KWM-380

Service Bulletins

AC-3803 CONTROL INTERFACE KIT (641-7150-001)
CONTROL INTERFACE CIRCUIT CARD (638-6910-001)

SERVICE BULLETIN NO 1

Control Interface Circuit Card Assembly, REV E
Figure 1

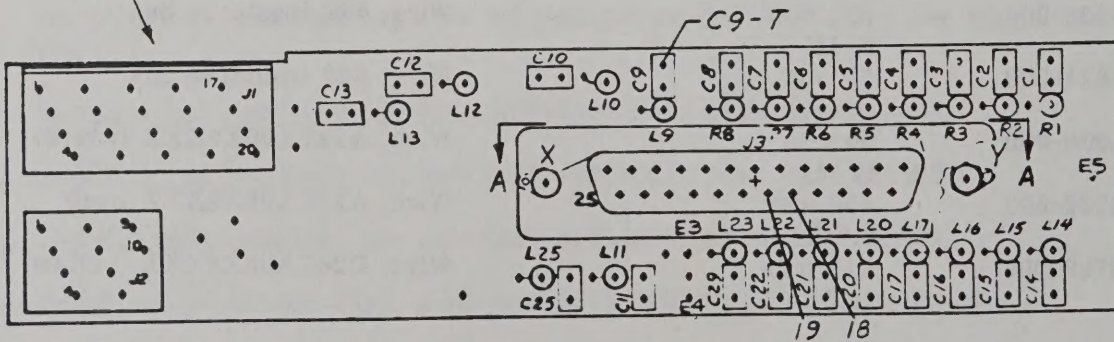
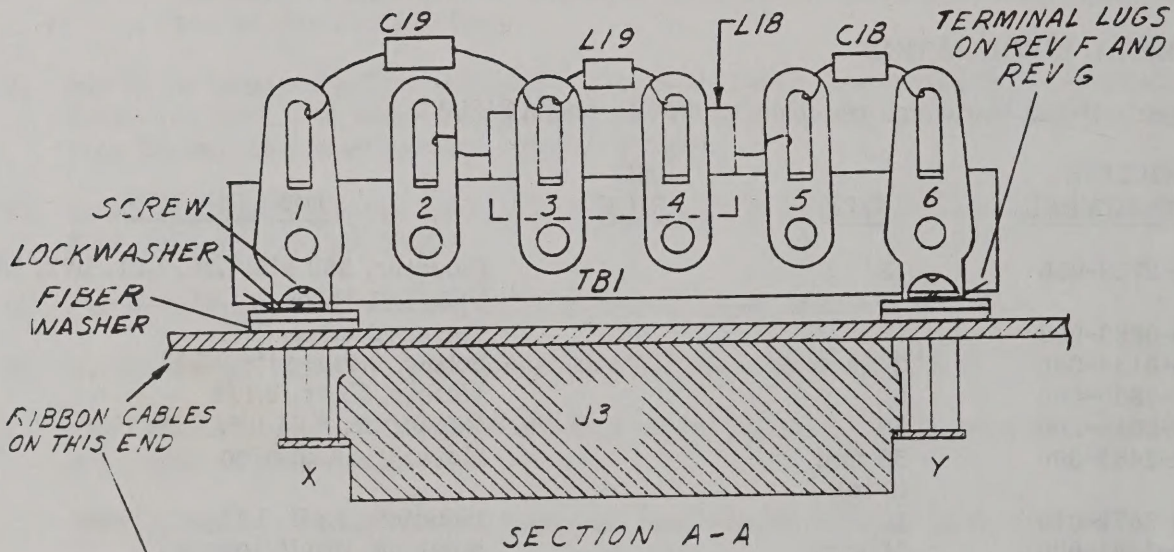
NOTE: Figure 1 is the REV E configuration and figure 2 is the REV H configuration of the circuit card. Refer to figures 1 and 2 for location of components. Refer to figure 3 for a schematic diagram which includes the following changes. Use a 25- to 30-watt soldering iron with a tip designed for use with printed circuits. The tip should be clean to ensure proper melting of the solder prior to component removal or when securing new components to the card. Take care to avoid application of excessive heat.

- A. Remove and discard resistor R24 and capacitor C24.
- B. Remove 10-k Ω resistors R20, R21, R22, R23, and R25 and replace them with 560- μ H inductors L20, L21, L22, L23, and L25 (240-2723-050).
- C. Remove 10-k Ω resistors R11 through R17 and replace them with 560- μ H inductors L11 through L17 (240-2723-050).
- D. Remove and discard two screws and two flat washers that secure connector J3 to the circuit card. Save the hex posts and lockwashers for reassembly. Circuit cards with REV F and REV G will have two terminal lugs attached to the circuit card by the J3 mounting screws. A white wire will be connected to one terminal lug. The other end of the wire will connect to the ground lug at J6 (AUD OUT) on the rear panel of the HF-380 or KWM-380 when the circuit card is installed.

- E. Install terminal strip TB1 (306-0083-000) as shown in figure 2 using two screws (343-0134-000), two lockwashers (removed in step D), two terminal lugs (removed in step D), and two fiber washers (302-4800-000).
- F. Install 0.01- μ F capacitor C19 (913-5019-200) from TB1-1 to TB1-3 using sleeving (152-2483-000) on the leads.
- G. Install 0.01- μ F capacitor C18 (913-5019-200) from TB1-5 to TB1-6.
- H. Install 560- μ H inductor L19 (240-2723-050) from TB1-3 to TB1-4.
- I. Install 2- μ H inductor L18 (240-0979-010) from TB1-2 to TB1-5 using sleeving (152-3991-000) on the body of L18.

P/O Receiver/Exciter Circuit Card A3
Figure 1

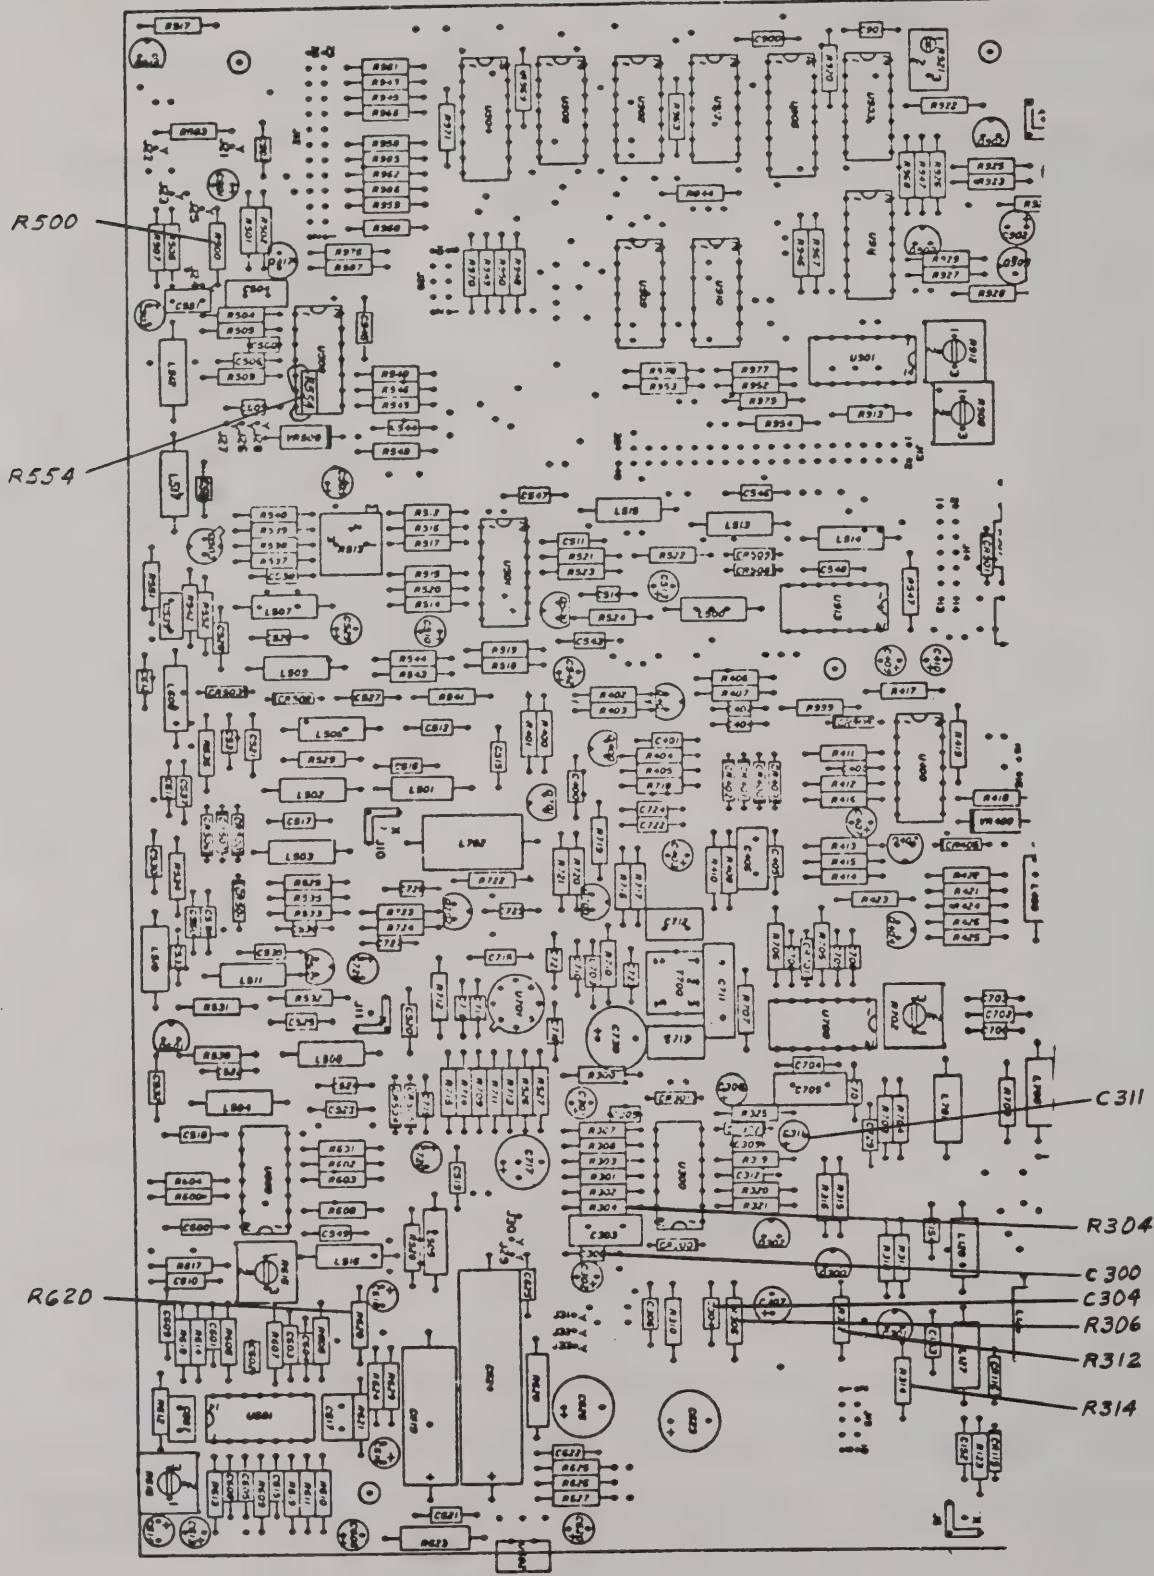
- C. Remove 100-k Ω resistor R554 and replace it with a 1-M Ω resistor (745-2449-000).
- D. Remove 270- Ω resistor R500 and replace it with a 3.3-k Ω resistor (745-0767-000).

- E. Remove 33-k Ω resistor R620 and replace it with an 18-k Ω resistor (745-0794-000).
- F. Remove 1- μ F capacitor C311 and replace it with a 0.22- μ F capacitor (184-9102-310).

- G. Remove 1-M Ω resistor R304 and replace it with a 100-k Ω resistor (745-0821-000).
- H. Remove 0.01- μ F capacitor C300 and replace it with a 1000-pF capacitor (913-3281-270).

- I. Remove 0.1- μ F capacitor C304 and replace it with a 4.7- μ F capacitor (184-9102-390). The negative lead of the capacitor should be connected to the hole on the left.

- J. Remove 1-k Ω resistor R306 and replace it with a 100- Ω resistor (745-0713-000).
- K. Remove 47-k Ω resistors R312 and R314 and replace them with 10-k Ω resistors (745-0785-000).

P/O Synthesizer Card A5A1 (638-6916-001)
Figure 1

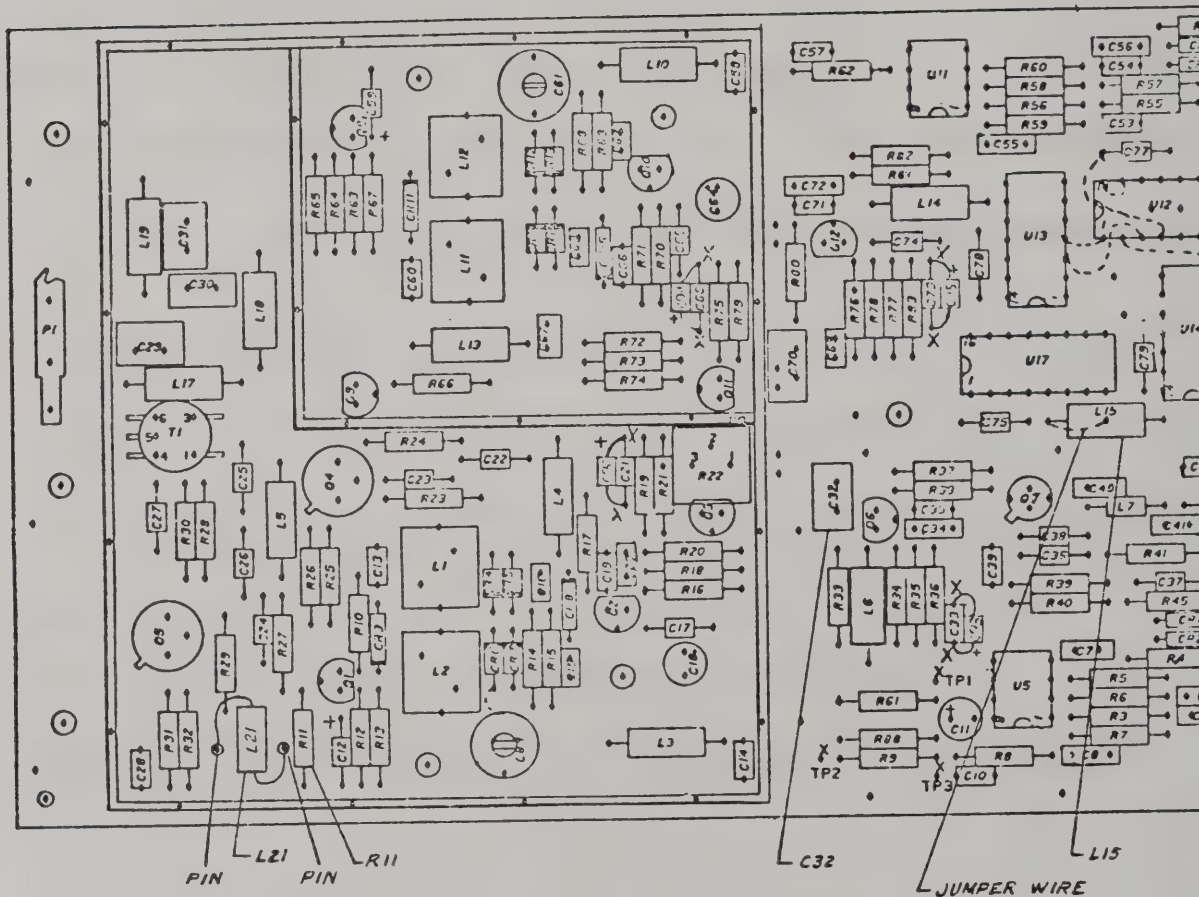
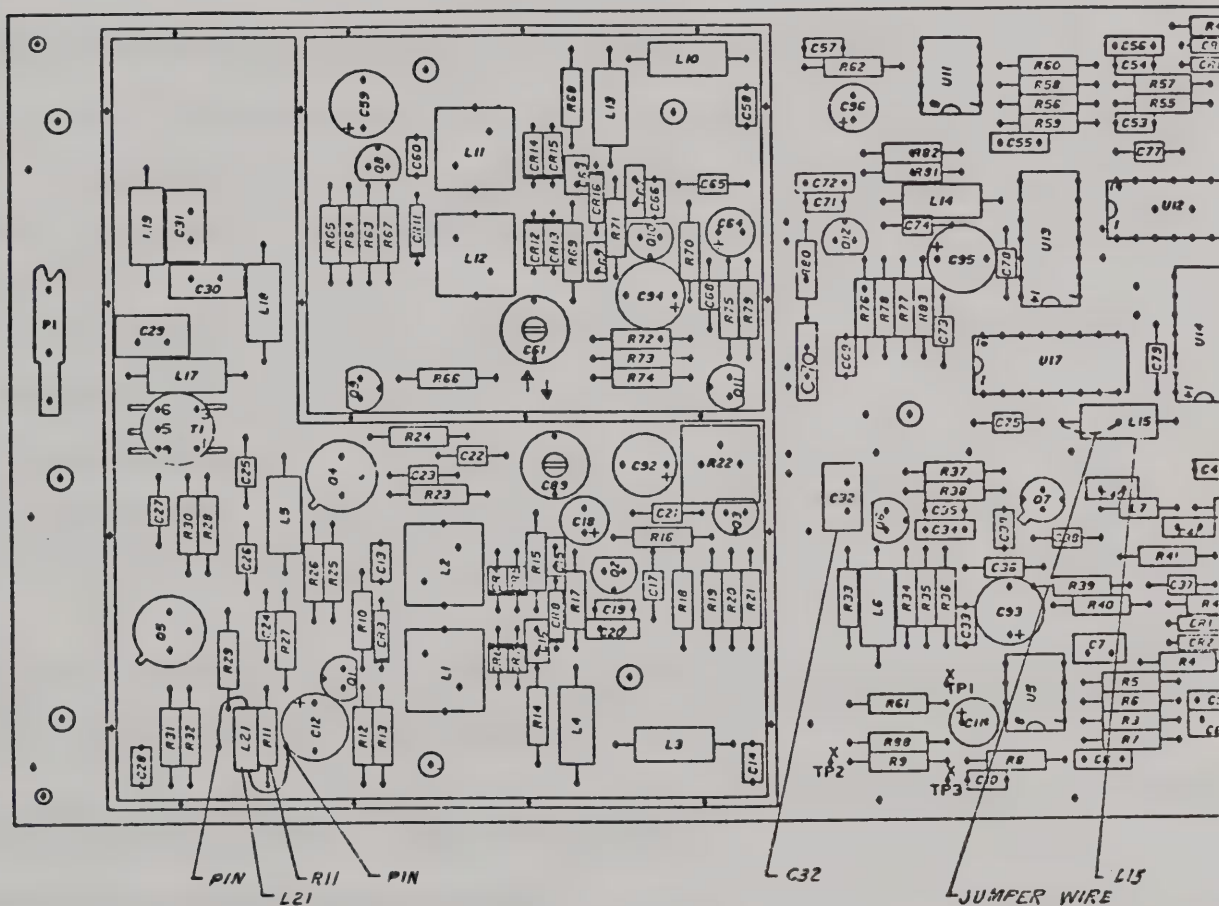
- D. Remove the shield cover from A5A1 card (638-6916-001, -002) by removing 19 screws.
- E. Remove A5A1 from A5 assembly by removing seven screws.
- F. On the top of A5A1, cut circuit trace at right lead of coil L15.

- I. Connect 4.7- μ H coil (240-1576-000) between the two new pins. Use sleeving (152-2483-000) on L21 leads if needed.
- J. Remove the 27-pF capacitor C32 and replace it with an 18-pF capacitor (913-1098-030).

Mic Jack J2, Orientation Diagram
Rear View of Front Panel
Figure 2

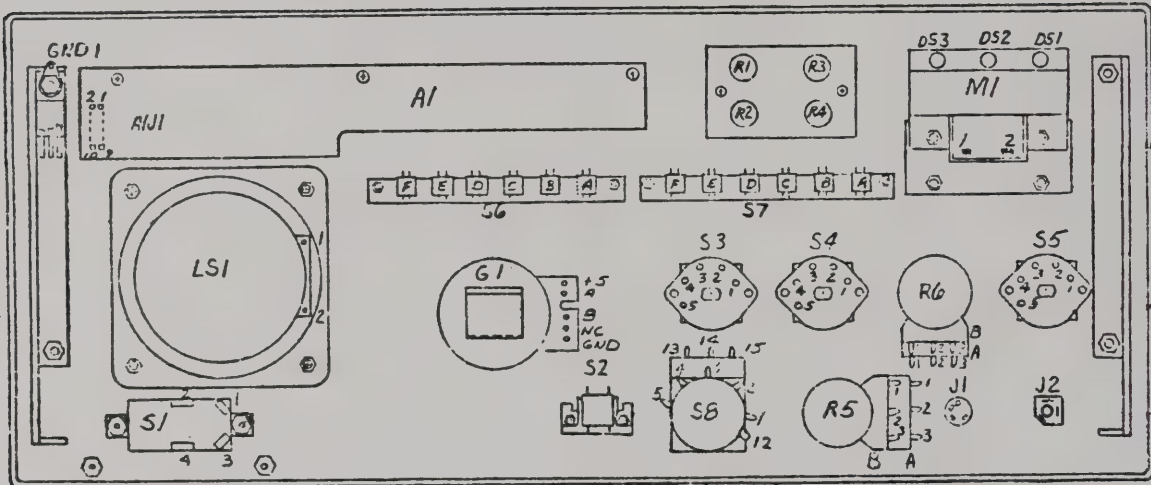
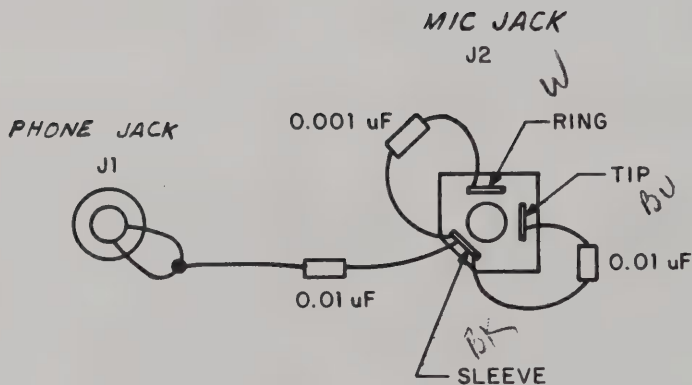
- C. Unsolder and remove the wires connected to mic jack J2 (figure 1).
- D. Remove and discard J2 by removing the nut that secures the jack to the front panel. Discard the bypass capacitors mounted on the jack.
- E. Install a new jack (647-2739-001) with the orientation shown in figure 2 using a black nut (334-1657-020).

P/O KWM-380/HF-380 Interconnect Diagram
Figure 3

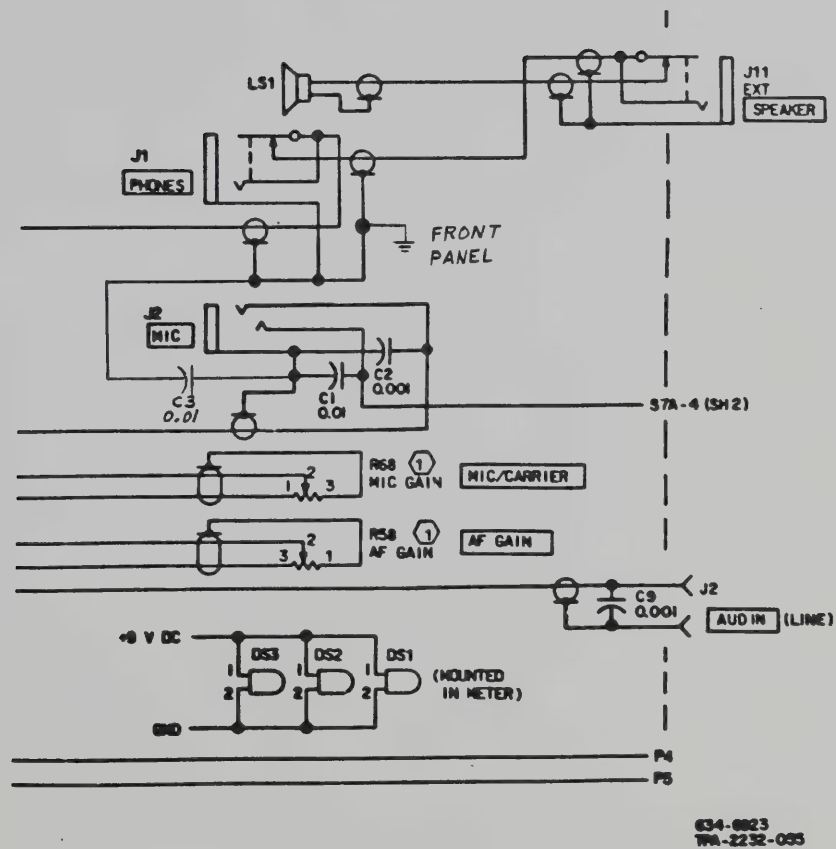
NOTE: Refer to figure 3 for an interconnect diagram which includes the above changes.

P/O Control Card A8
Figure 1

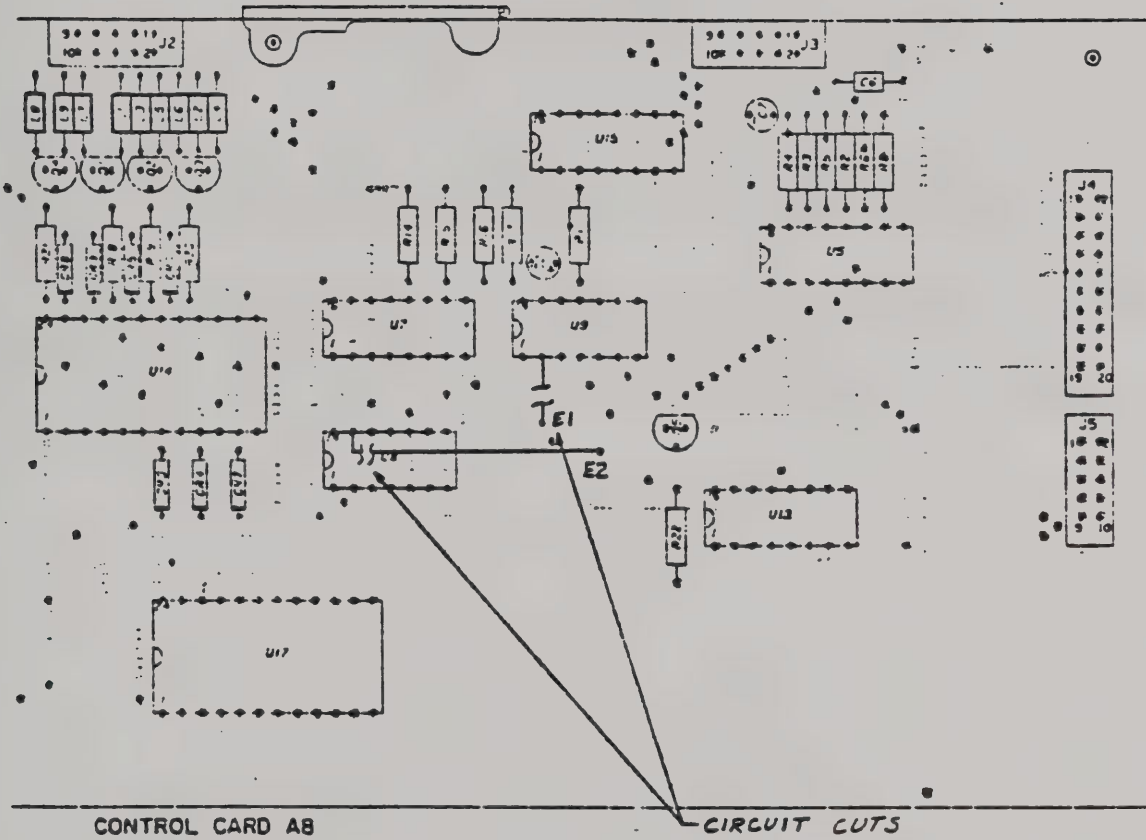
NOTE: Refer to the control card A8 instructions, CPN 523-0770685, figure 5, located in the back of the KWM-380/HF-380 service manuals and to figure 1 of this bulletin while performing steps E through I. Refer to figure 2 while performing steps J and K. Figure 3 shows the changes in steps F through I schematically.

- E. Remove 100- μ H coils L1 through L9 and replace them with 560- μ H coils (240-2723-050).
- F. Cut the circuit trace from U9-2 to E1.
- G. Cut the circuit trace from U8-13 to E2.
- H. On the bottom of the card, install a jumper wire (422-2400-020) from E1 to U9-4.
- I. On the bottom of the card, install a jumper wire (422-2400-020) from E2 to U8-12.
- J. Install two cable clamps (150-0873-010) in the synthesizer compartment as shown in figure 2.
- K. Route the two cables on the back of the synthesizer assembly through the cable clamps and out the end of the card cage. This will hold the cables away from the circuit card components.
- L. Reassemble the transceiver in the reverse order of disassembly.
